**COOK INLET HOUSING AUTHORITY
TYONEK TERRACES**
Anchorage, Alaska

*Kramer Electrical
Red Line Drawings*

NAME OR TYPE OF PROJECT
Tyonek Terrace
Electrical

TYPE & DATE OF PLANS
As-Built
September 15, 2003 34x26 26 Pages

SHEET NO. **E3.1**

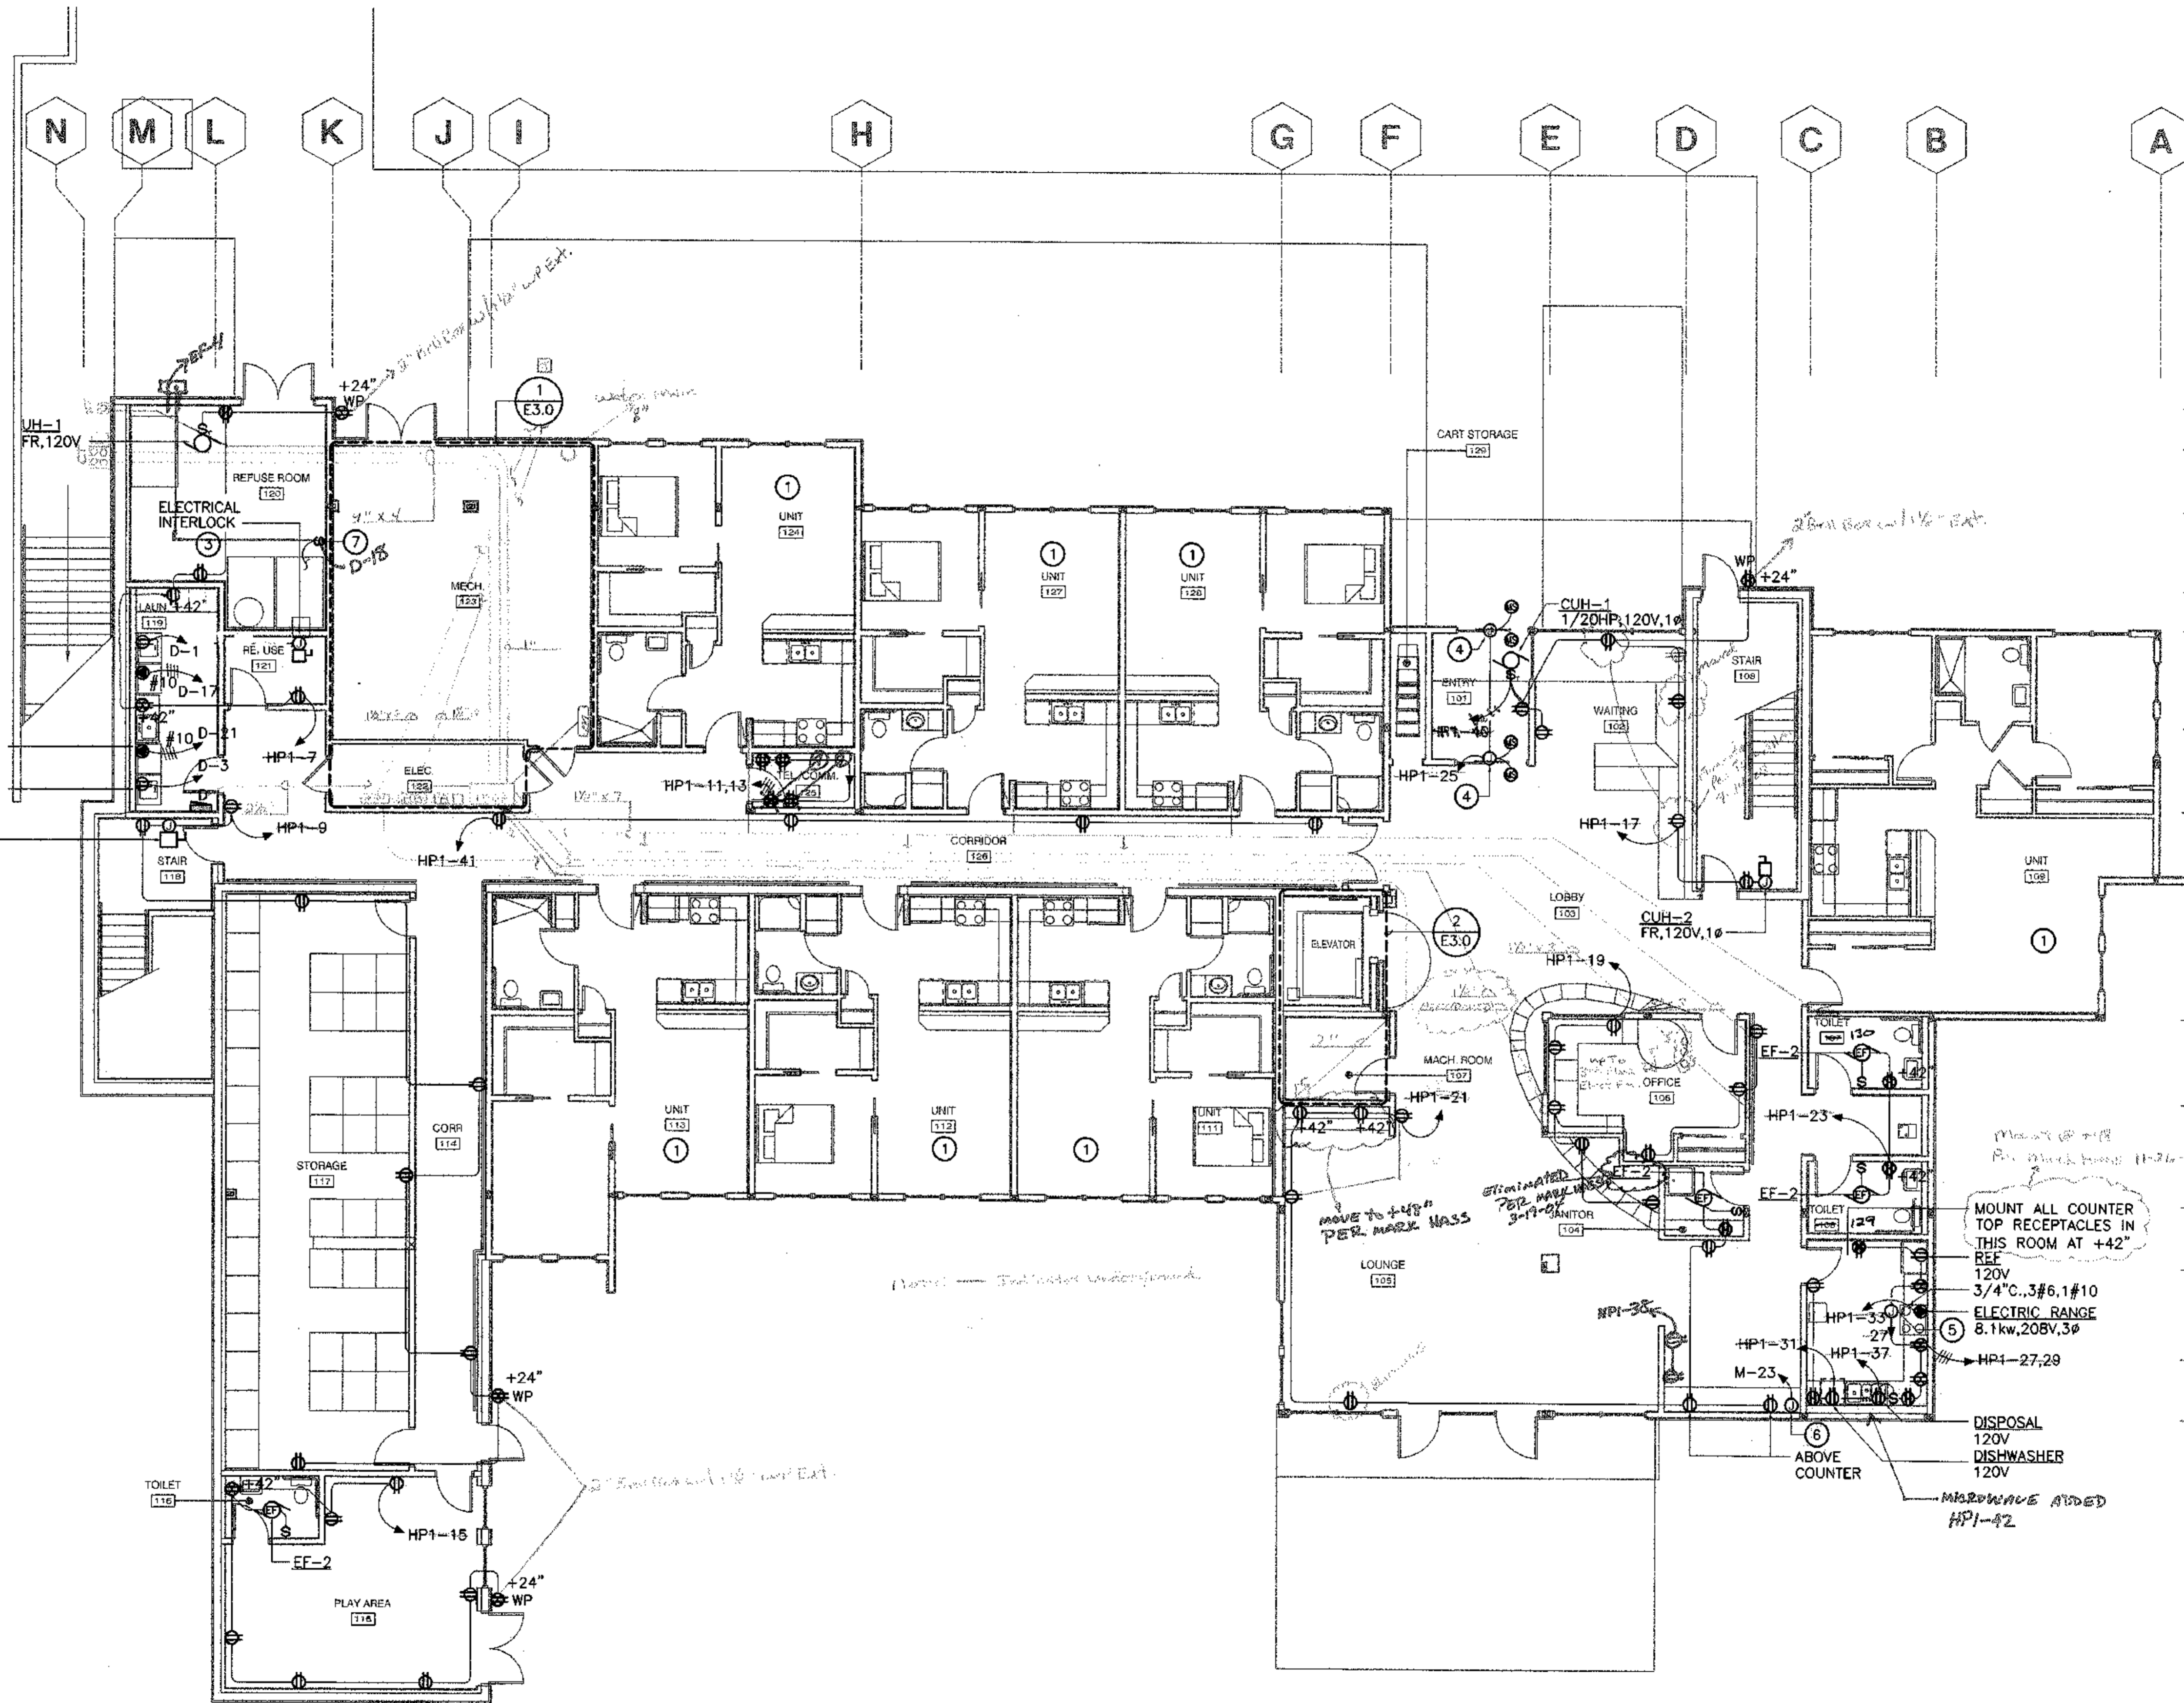
- 7 SWITCHED CONTROL FOR EF-4. PROVIDE LABEL "GARBAGE CHUTE EXHAUST FAN". *NOTE: EF-4 MOVED FROM ROOF TO EXTERIOR WALL REFUSE ROOM #120 AT MARKED LOCATION*

SHEET NO.
E5.0

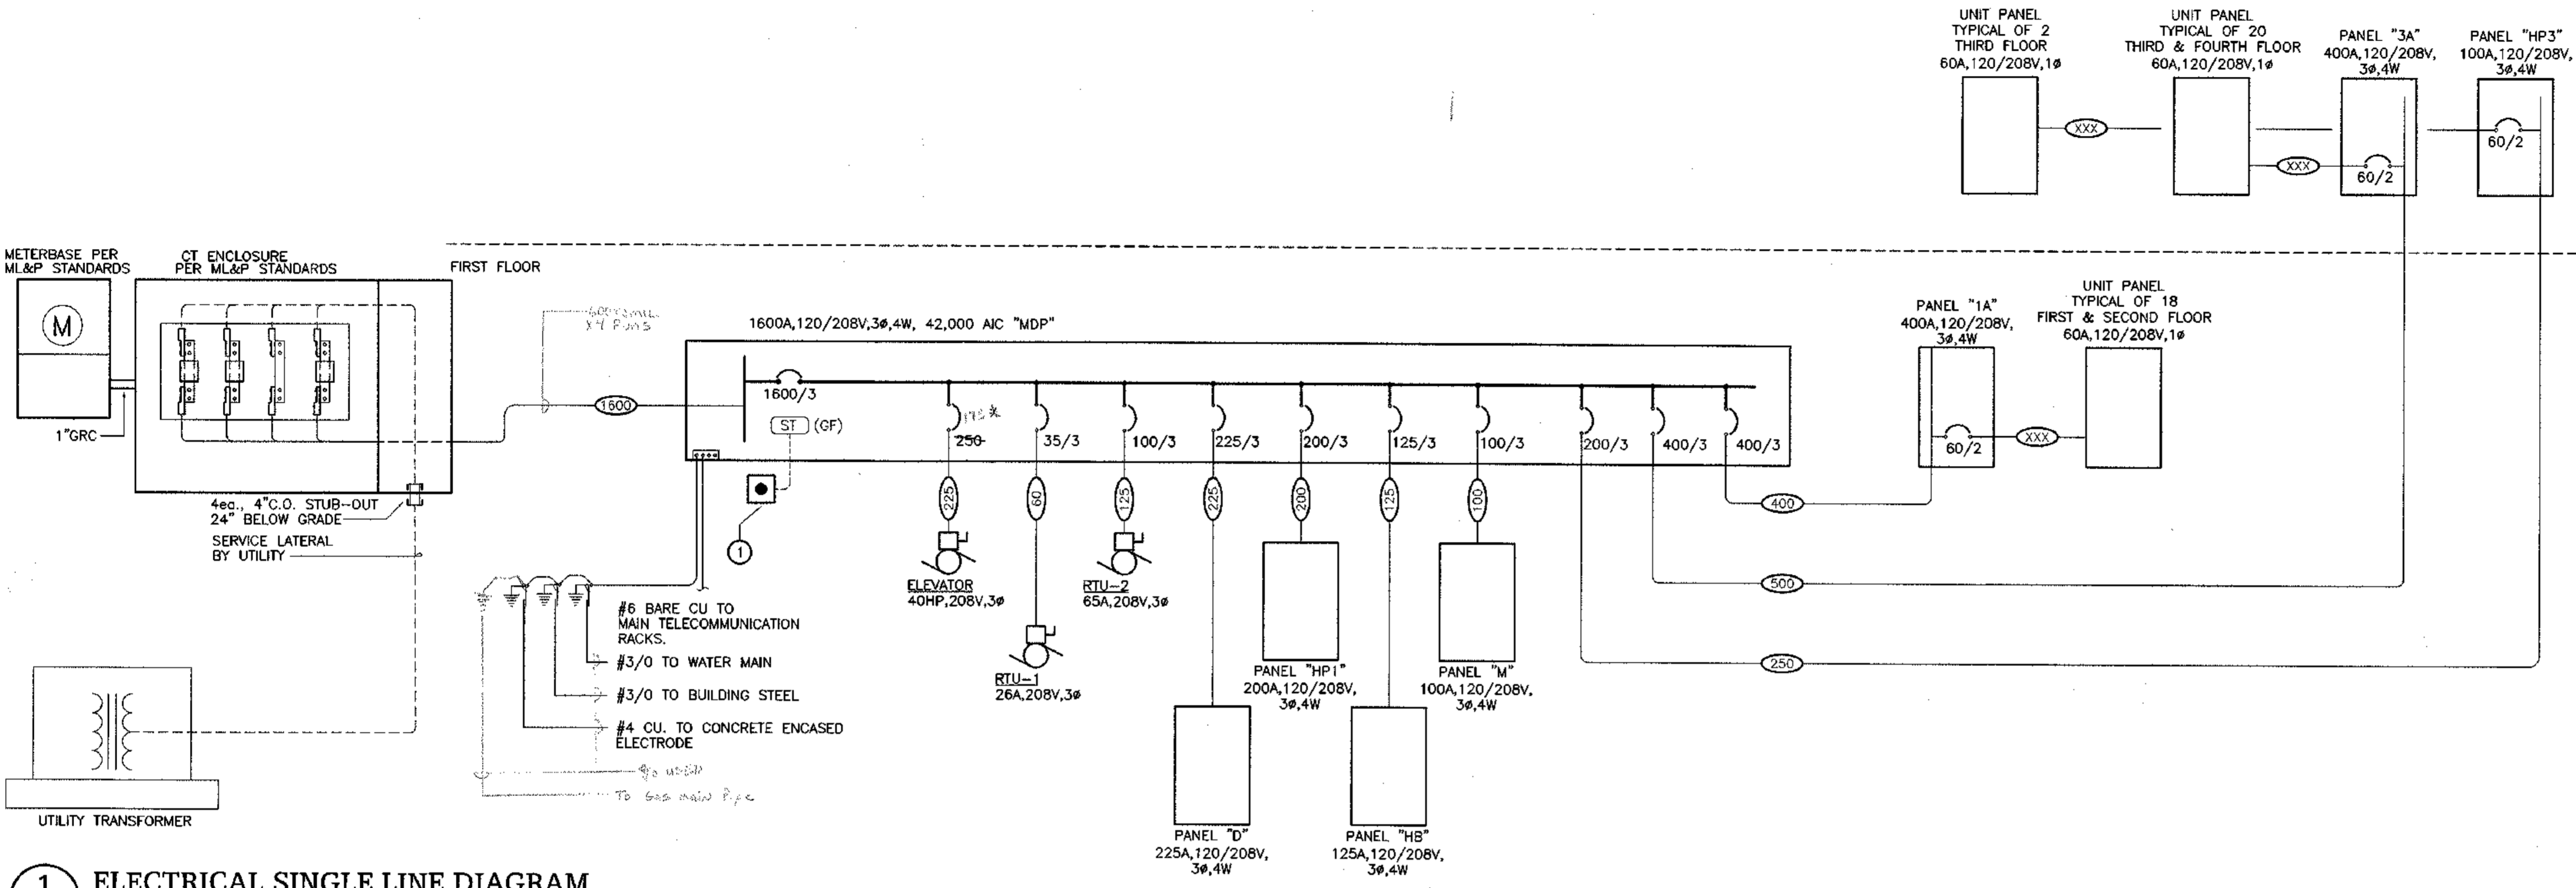
Run 1" Conduit 2 Approaches By Tom Allen 10-2003
 5-10-04
 * Elevator Down Speed - 175 R Barbra.
 And 1/2" w/ #6 Ground (Tom Allen)
